Re: Volcano Heights Drainage Compilation Report, Engineer's Stamp
Dated 12-12-2011 (C10/D000)

Re: **Volcano Heights Drainage Compilation Report**

CITY OF ALBUQUERQUE
PUBLIC WORKS DEPARTMENT
ENGINEERING GROUP
VOLCANO HEIGHTS
CONCEPTUAL DRAINAGE COMPACTION PLAN

PLATE 1

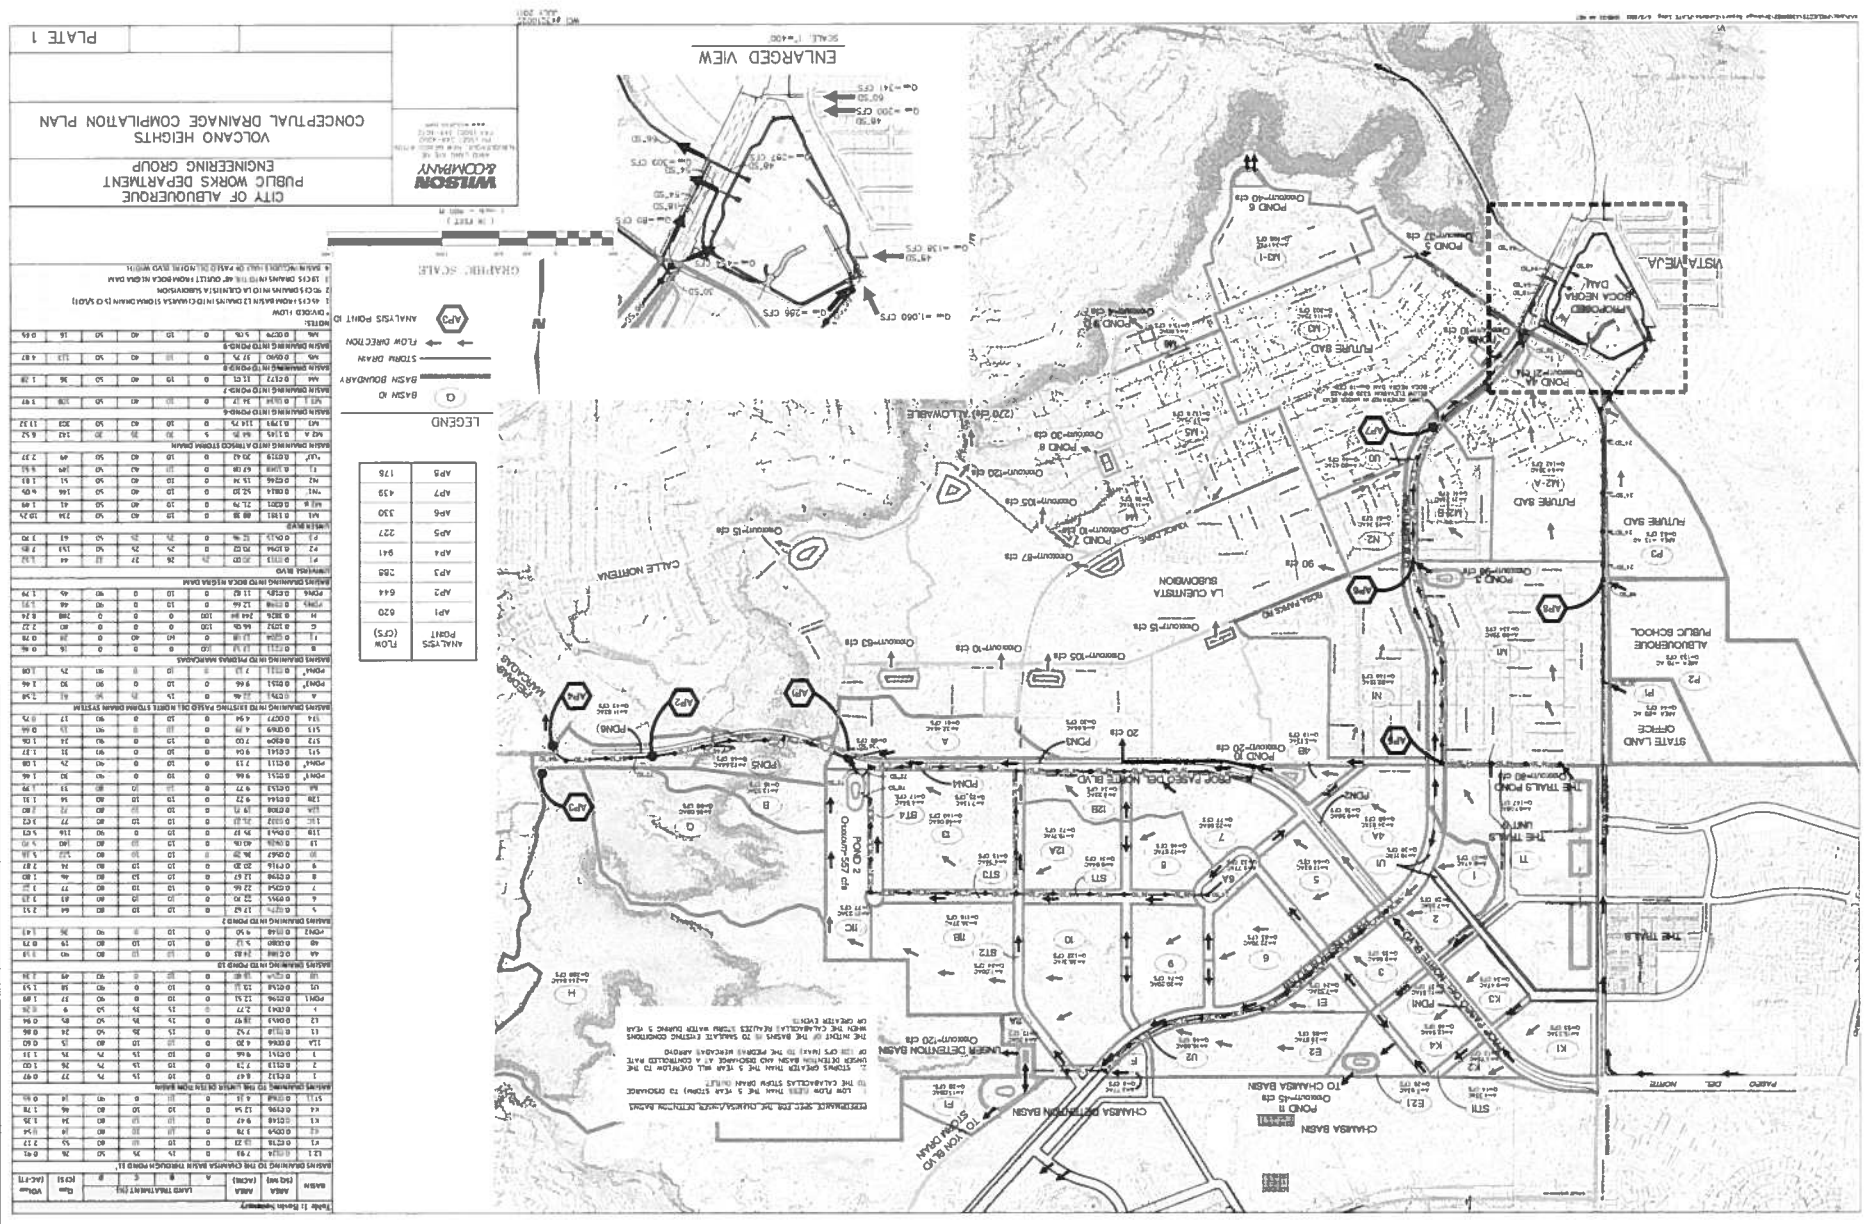
6. **Flow numbers for Basins K2, M5, M6, and T1 are not the same on the Plate-1, Table-1/Plate-1 and AHYMO calculations. T1 basin area is different from the AHYMO calculations and what is shown on the Plate-1.** All numbers corrected.

- Flow number for Basins K2, M5, M6, and T1 are not the same on the Plate-1, Table-1/Plate-1 and AHYMO calculations. T1 basin area is different from the AHYMO calculations and what is shown on the Table-1/Plate-1.
